City of San Diego
Development
Services
Department

Environmental Impact Report

LDR No. 96-7902
SCH No. 97111070

SUBJECT: BLACK MOUNTAIN RANCH (SUBAREA I) SUBAREA PLAN in the NORTH CITY FUTURE URBANIZING AREA (NCFUA). GENERAL PLAN AMENDMENT, NCFUA FRAMEWORK PLAN AMENDMENT, SUBAREA PLAN, and MULTIPLE HABITAT PLANNING AREA (MHPA) BOUNDARY ADJUSTMENT for development of the remaining 1,408 acres of Subarea I in the NCFUA of the City of San Diego. The Subarea Plan would refine the existing NCFUA Framework Plan by proposing siting and land use designations for future commercial, industrial, residential and public facility land uses, and specific locations for roads. The Subarea Plan is a prerequisite for voter consideration of a General Plan phase shift from Future Urbanizing to Planned Urbanizing and no approvals for specific development under the Subarea Plan are being considered at this time. The proposed future development areas under the Subarea Plan would be comprised of the remaining 893 acres from the previously approved 3,777-acre Black Mountain Ranch II Vesting Tentative Map/Planned Residential Development Permit/Resource Protection Ordinance Permit/Development Agreement (DEP

FIGURE 3-6

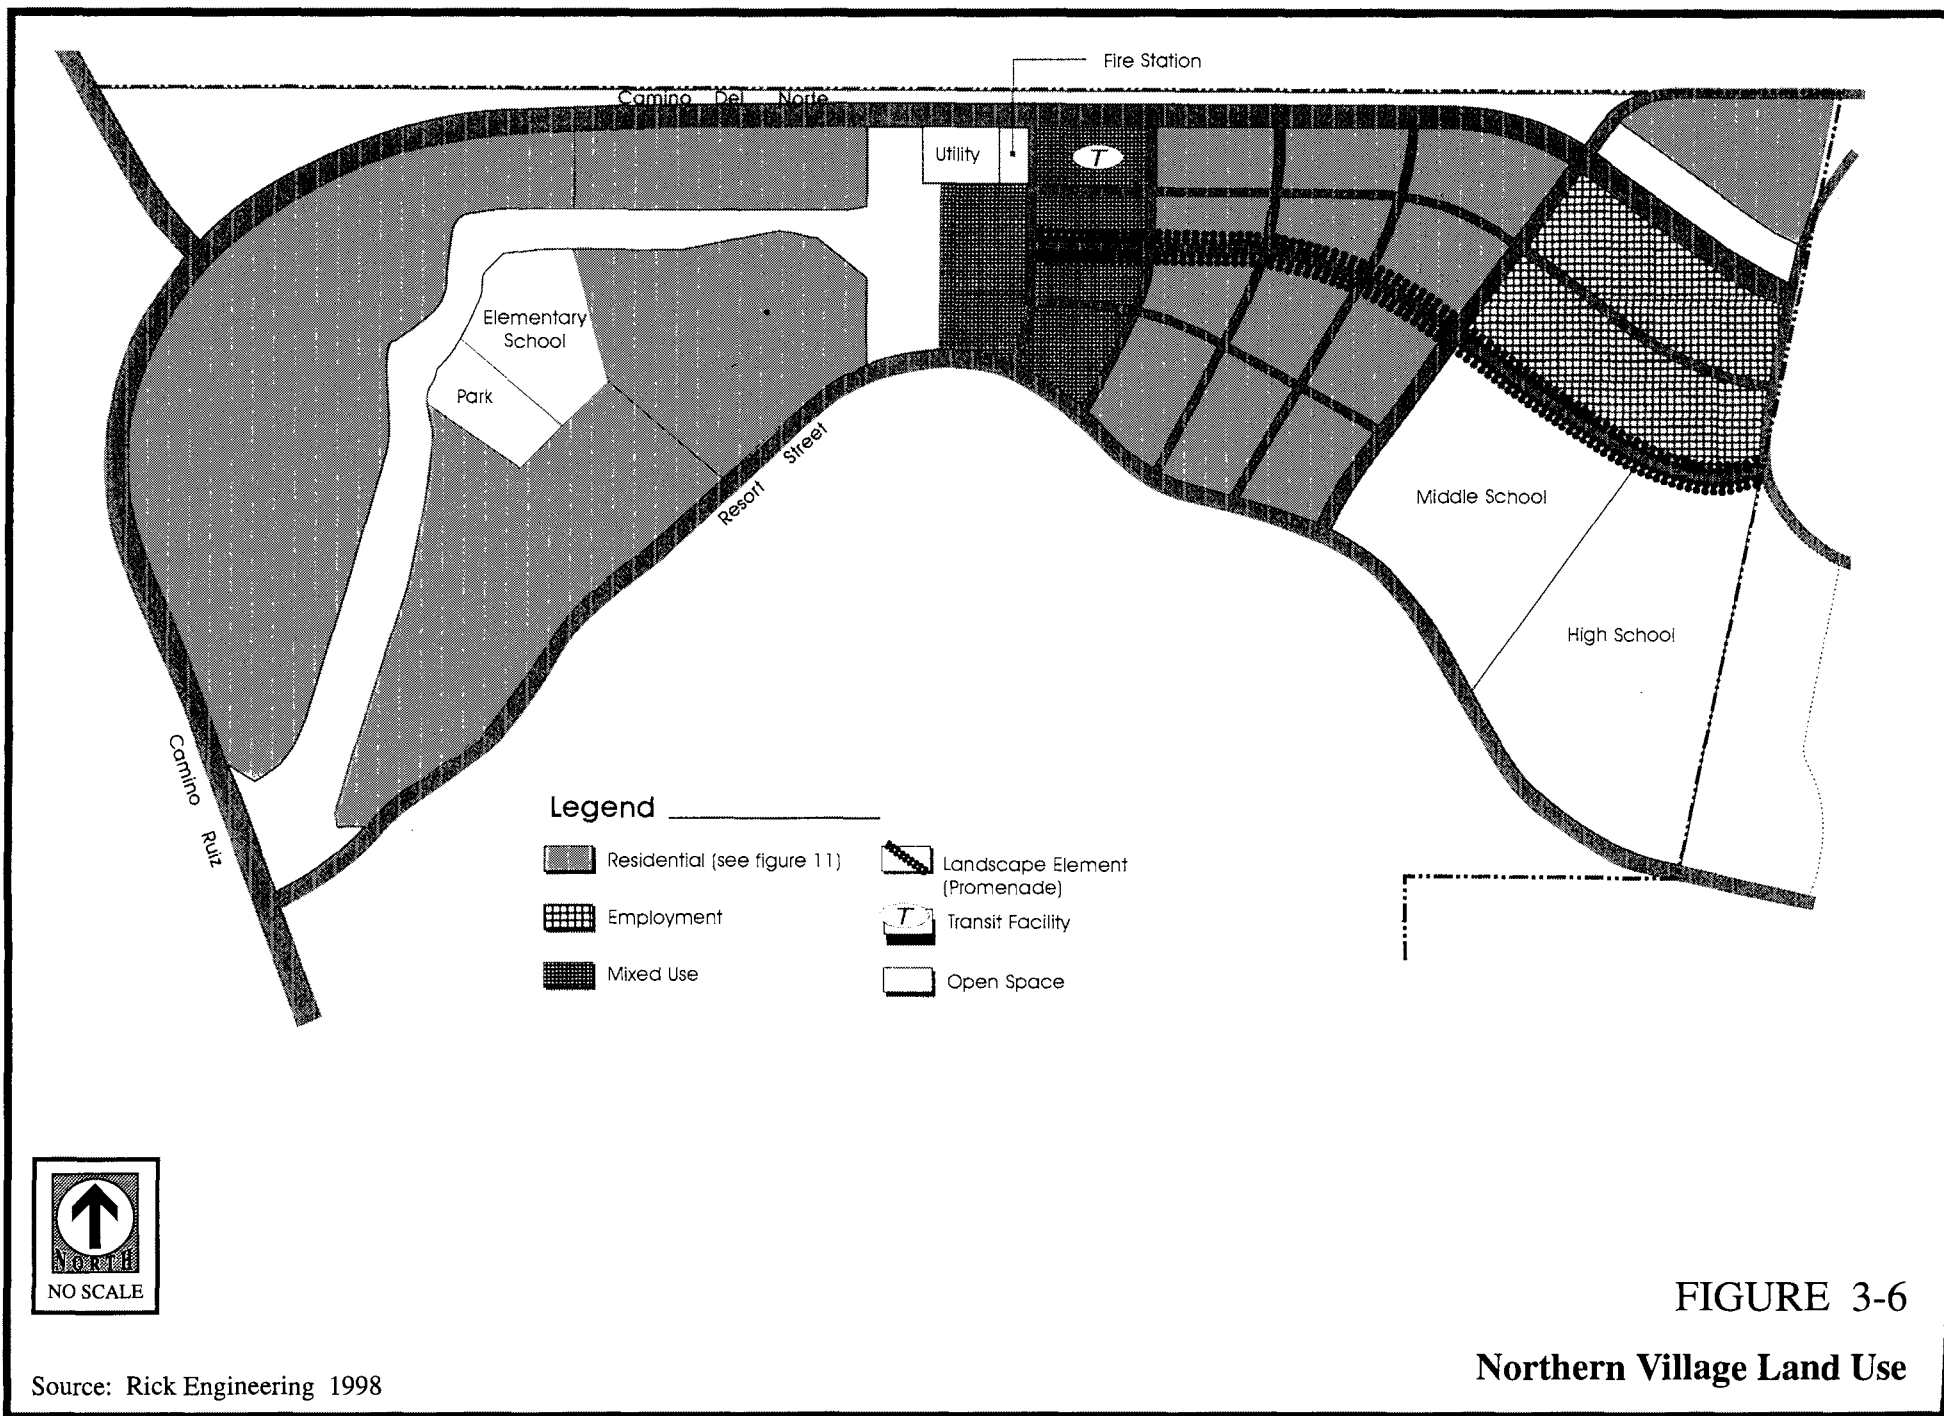
- 57 The text of the project description section of the TEIR does not accurately describe the proposed school sites. Figures 3-6 and 3-2 correctly indicate that a middle school and two-thirds of a high school is proposed on the eastern boundary of the Northern Village. The text should be revised to reflect this. The project description should also note that the proposed locations of the schools are different than what was anticipated in the Framework Plan (Figure 3-1), but that the changes will not result in a significant impact.

FIGURE 4B-11

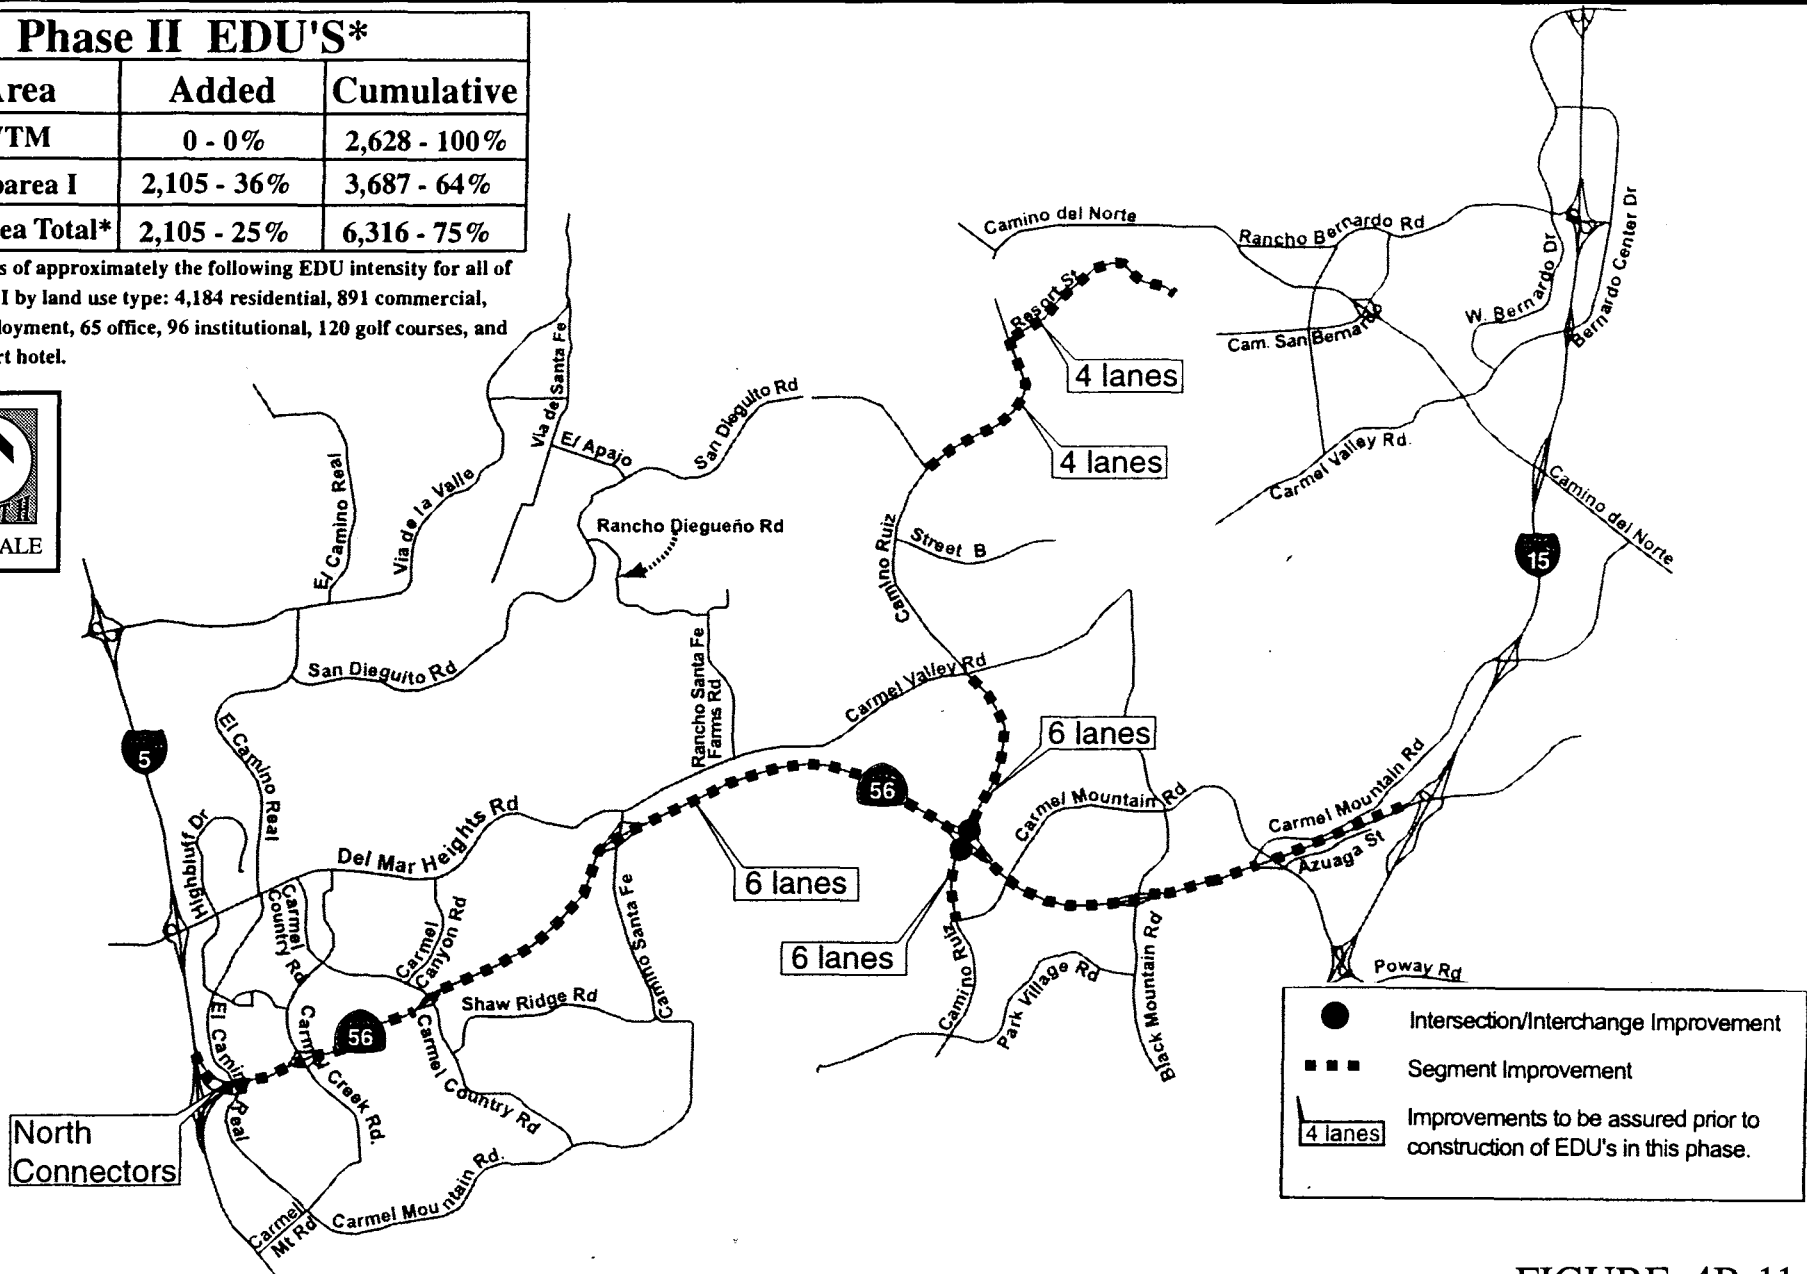
- 102 The phased construction of road improvements shown on Figures 4B-11 and 4B-12 will place a hardship on our community because it delays access to the west. We are in the Solana Beach School District but most of the properties do not have legal access to the west since the Rancho Santa Fe Association placed a gate at Zumaque Road and SA 680 was eliminated from the County's General Plan. Making the connection from Camino Del Norte to Camino Ruiz to San Dieguito Road part of the last phase of construction is not acceptable. These are important Circulation Element roads and vital to our lifestyle. Delaying this link to the last phase of construction will place a direct hardship on our community because through traffic from the Black Mountain Ranch development will drive down our privately maintained but public County Service Area road in an attempt to get access through the Zumaque Gate. This should be addressed in a phasing analysis of the traffic study.

**Southeast Perimeter Property Proposed Impacts,
Vegetation and Sensitive Species**

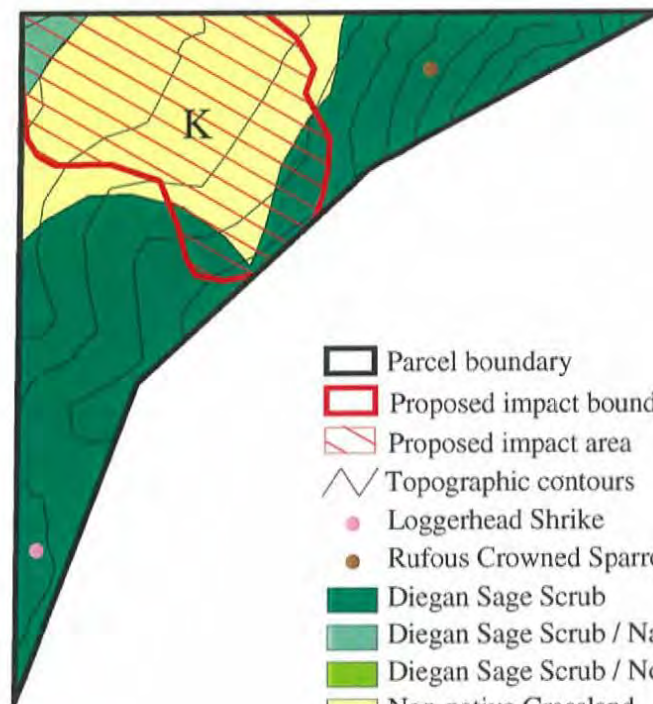
The purpose of this letter is to inform you that there are several errors in the biological mapping of our property in the draft EIR (see Figure 4C-5). More portions of the property have been cleared than are shown in this map. We realize that this map was never intended to be precise. Nonetheless, we want to bring these facts to your attention because we do not want negative repercussions or misunderstandings, now or later, since the MHPA boundary passes through our property.

FIGURE 4D-3
Locations of Desilting Basins

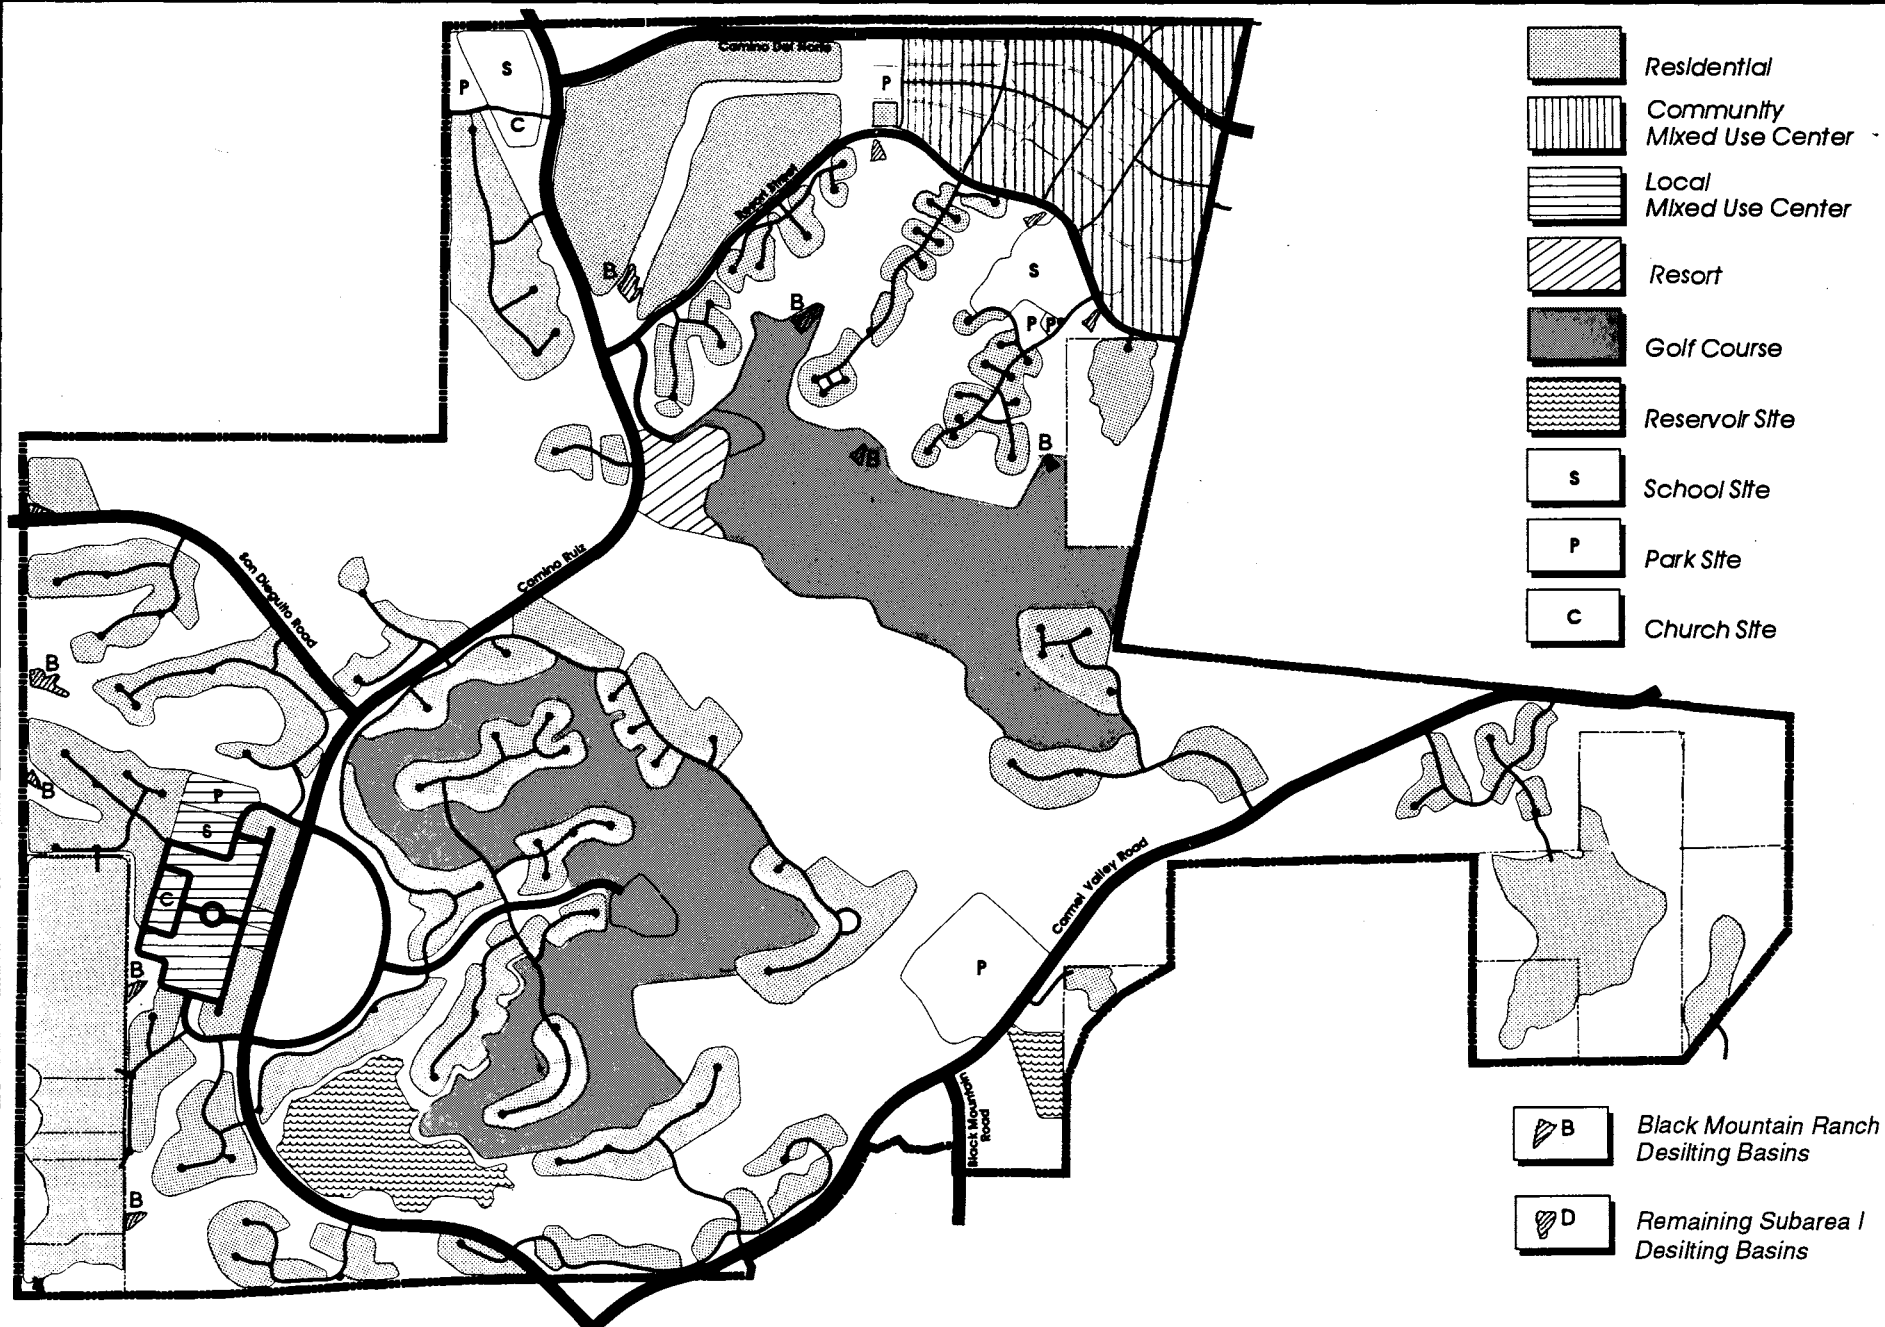
- 96 The FEIR should replace Figure 4-D-3 because it is outdated and shows a park and school adjacent to Santa Fe Hills. On page 24, the words "or less" should be added after (1du/2acres) because most of the lots within Santa Fe Hills are developed from 2.5 acres to 10 acres. Please correct the first paragraph on page 58 to read Santa Fe Hills instead of Section 26. Figure 4A-1 should reflect the Open Space areas in the Santa Fe Valley Specific Plan (Lusardi Canyon). Figure 4A-4 should show the trails that were actually approved in the Santa Fe Valley Specific Plan which differ in type and location in some areas.

96. The underlying land use map used for Figure 4D-3 is out-of-date and the school and park sites have been relocated in the northern village. The figure is designed to show the location of the desilting basins, however, not the school or park, and the desilting basins' locations are correctly shown. The new locations of the schools and park do not impact the locations of the desilting basins; hence, no revisions to the figure are required.

FIGURE 4E-1
Hillside Review Overlay Zone
and Development Impacts Area

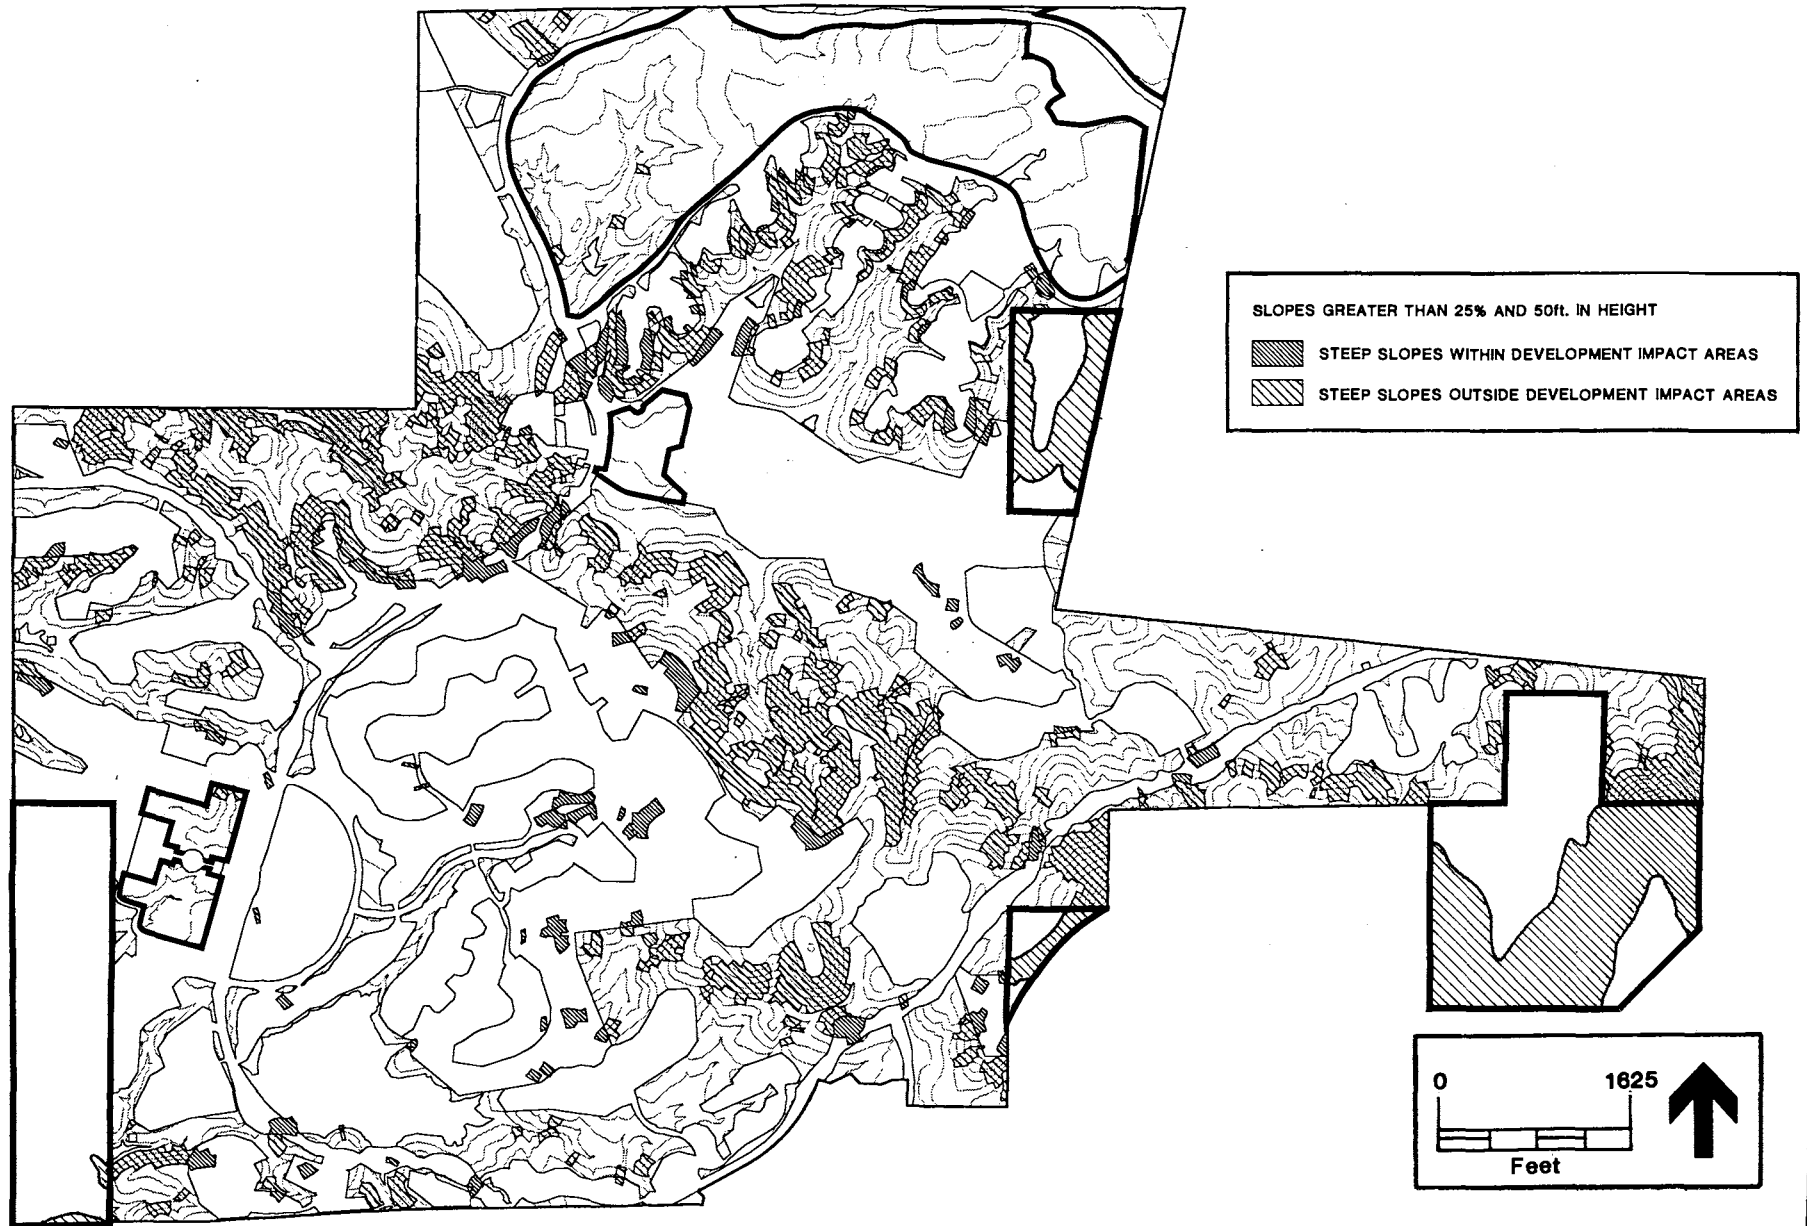
- 114 *Location of Open Space Bike Path:* The open space bike path is placed near, but not along the southern edge of the Lusardi Creek MHPA area. Figure 4A-12. In this configuration, the approximately 12 foot-wide trail easement will be constructed on steep slopes. See Figure 4E-1. This will result in the following problems:
